FLOOR PLAN

1 FLOOR PLAN
1/8" = 1'-0"

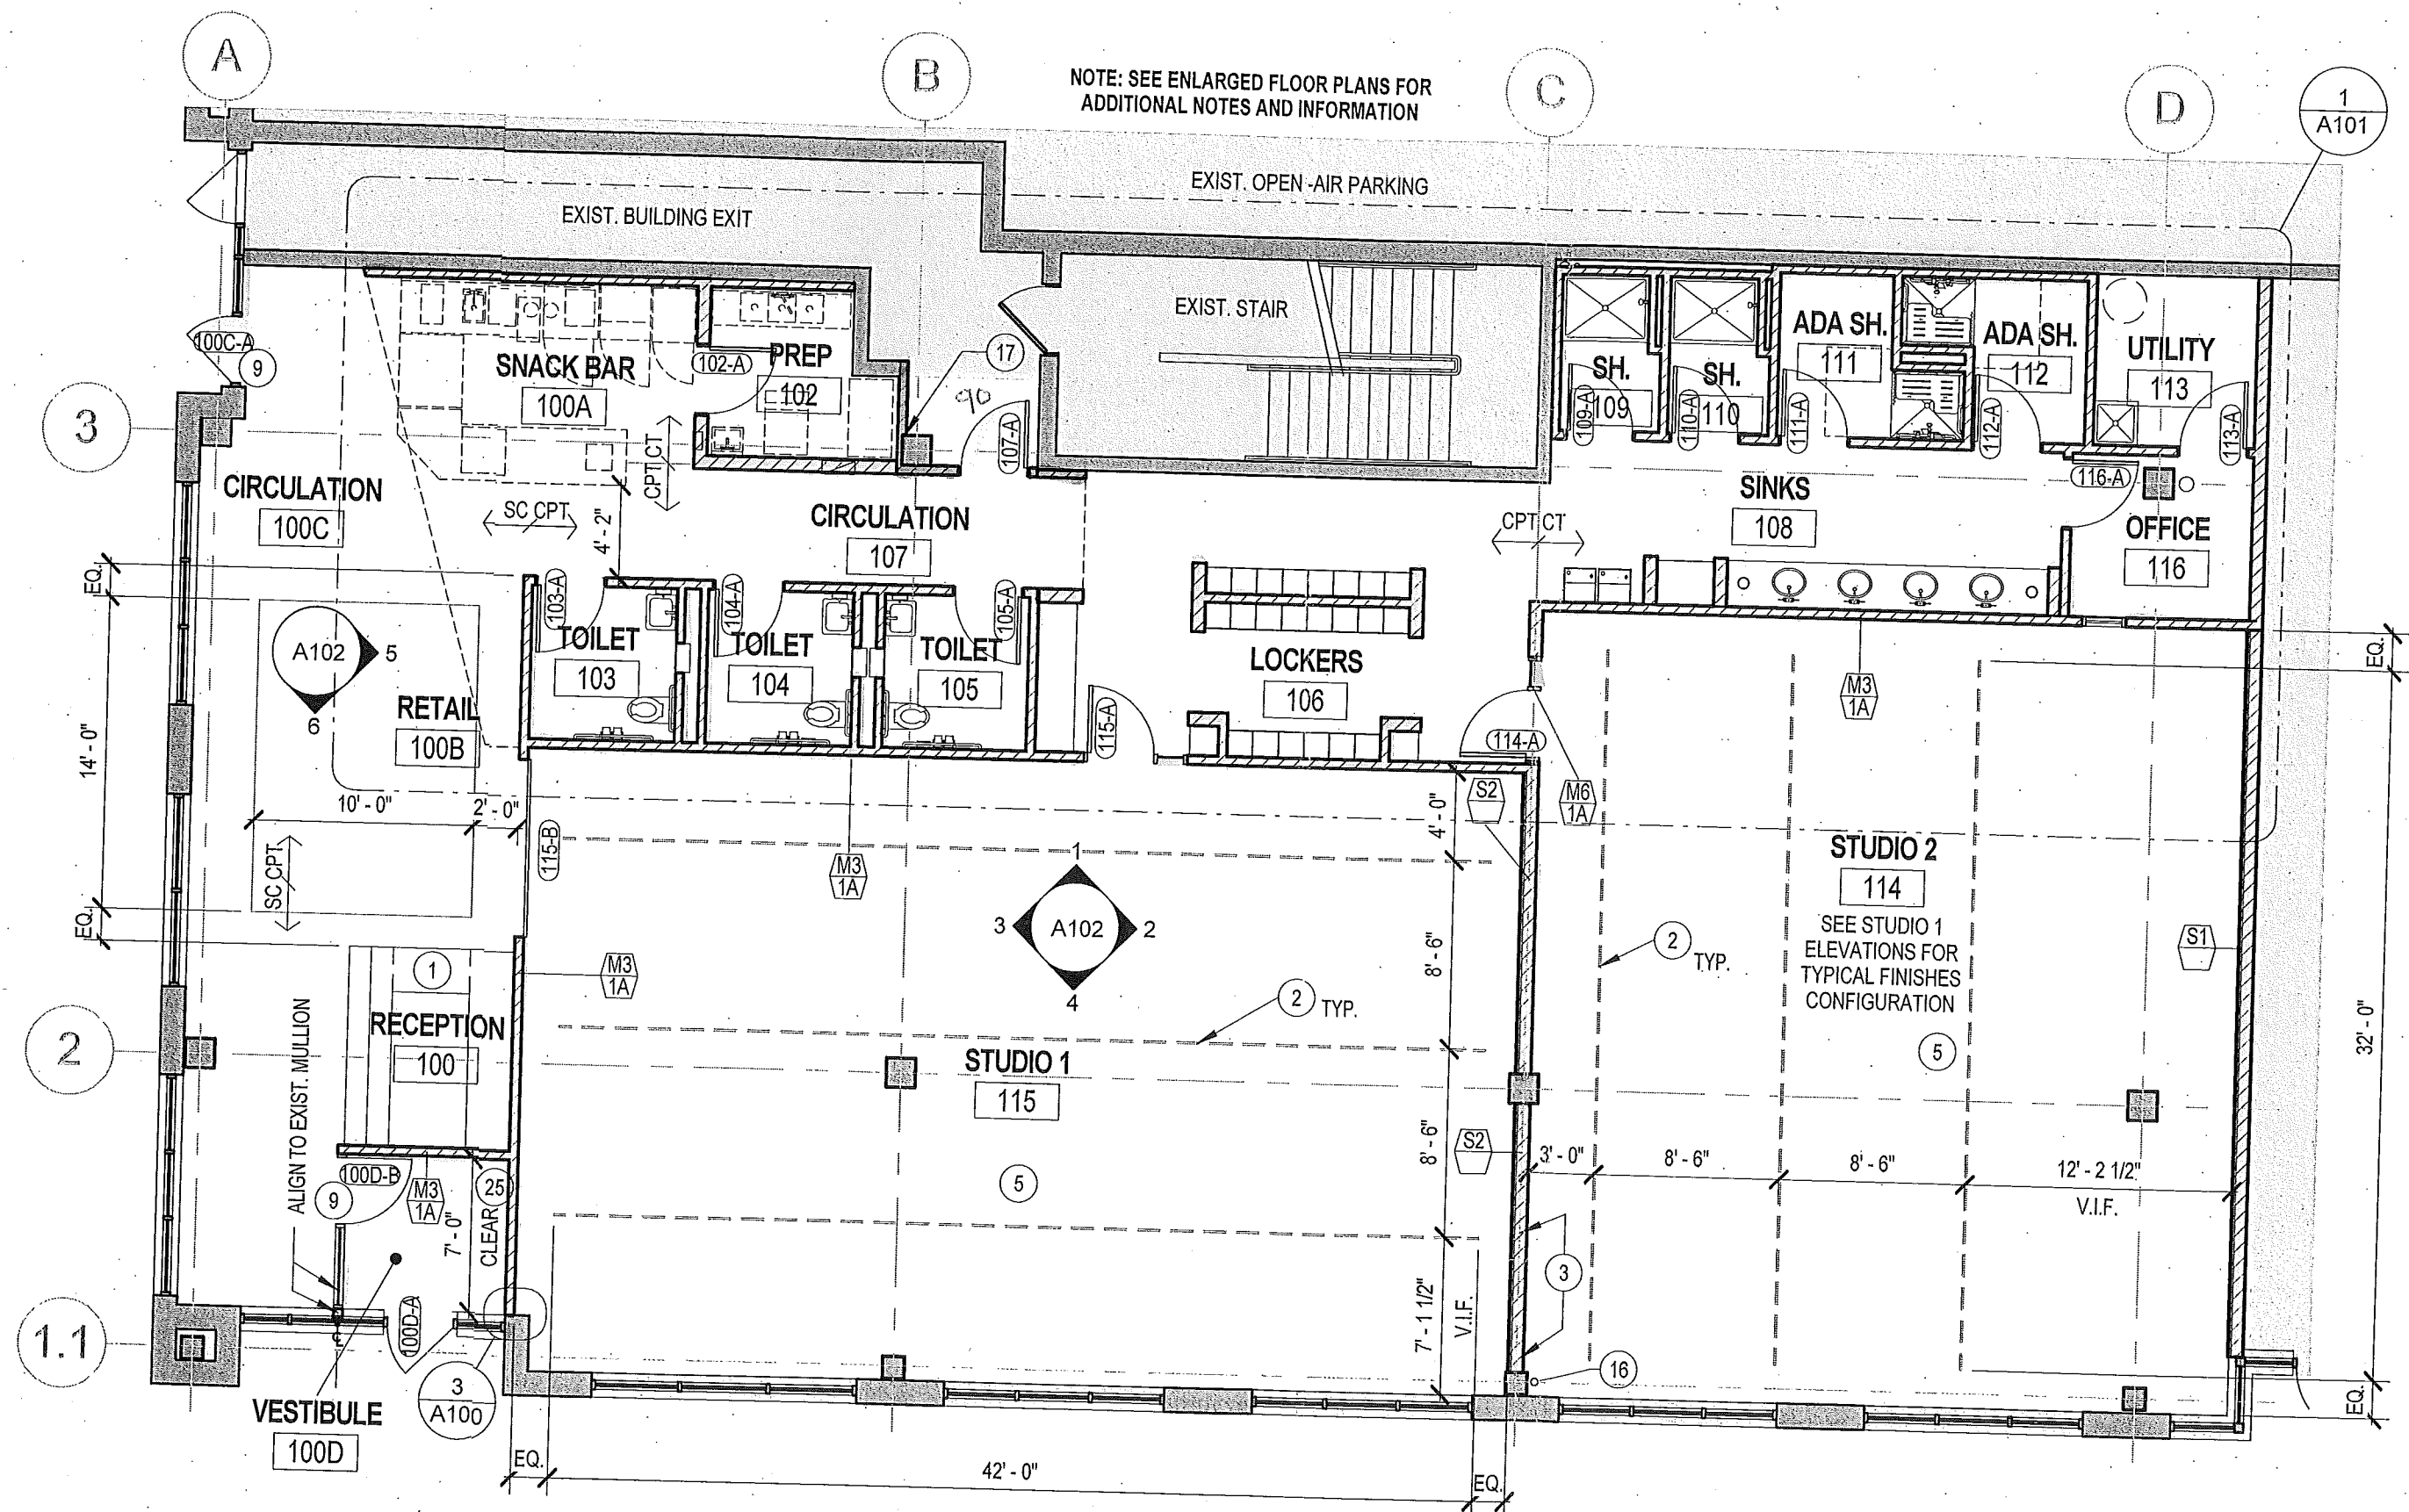
LEVER HANDLES OR APPROVED
SINGLE REPORT (NON-ROTATIONAL)
HARDWARE REQUIRED.
Provide accessible clearances at latch

EMERGENCY LIGHTING REQUIRED
Exit signage required

NOTE HANDICAPPED ACCESSIBILITY
REQUIREMENTS
EXACTLY PER CODE: ERRORS MUST
BE CORRECTED.

PANIC HARDWARE REQUIRED
